**Report to General Manager**

SUBJECT: North Sydney Olympic Pool Development Application Amendments Requested by the Independent Planner - Heritage Planners and Public Consultation Feedback

Table 1. Proposed Design Changes – Reference DA 347/19 - North Sydney Olympic Pool

Figure 4. View looking at the shade structure canopy over the Grandstand

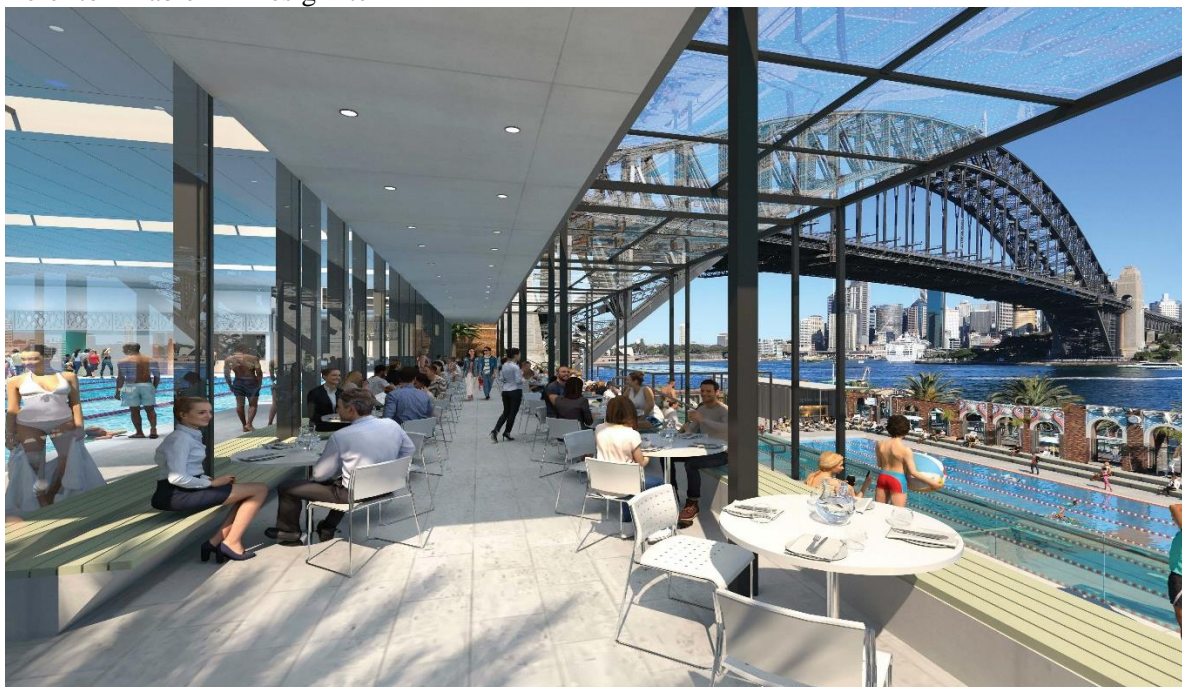
- Replacement of grandstand:
 - Independent engineering advice has confirmed that the existing grandstand is nearing the end of its structural life. It’s replacement therefore is accepted from a heritage viewpoint. Nevertheless, the height of the roof of the grandstand’s upper level has been lowered from the pre-DA proposal but is nevertheless visually prominent. The roof should be further lowered in order to reduce the impact of the new grandstand on the scale and form of the historic complex.

- Further details of the size and details of its structural supports and roofing structure are required to enable proper assessment. Larger scale cross-sections would assist.

Note: Brewster Hjorth Architects propose to modify their design to further reduce the height and size of the weatherproof canopy structure over the new Grandstand to address the heritage concerns raised by the independent heritage planner.

Note: The weatherproof canopy structure over the new Grandstand had already been reduced in size and height – as a result of the pre-DA meeting feedback on 26 August 2019 and is reflected in the current Development Application design.
